UNITED STATES PATENT AND TRADEMARK OFFICE

10/527,490

Office Action Summary	Application No. 10/527,490	Applicant(s) PETIT, DOMINIQUE	
	Examiner Nicholas Woodall	Art Unit 3733

DETAILED ACTION

Figure 1

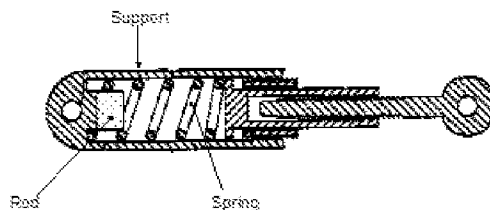
Atkinson discloses a device comprising a support, a rod, and a spring (see Figure 1 below). The rod extends from the support and is coaxial with the support. The spring is a helical spring formed from a plurality of turns forming a cavity having an inner diameter larger than an outer diameter of the rod such that the rod is positioned within the cavity of the spring, wherein an axis of the spring is parallel with and substantially coaxial with an axis of the support. The turns of the spring further define an outer diameter that is larger than an inner diameter of the support, such as the outer diameter

of the rod, such that at least a portion of the turns are embedded, i.e. to support tightly or firmly (www.dictionary.com), in the support.
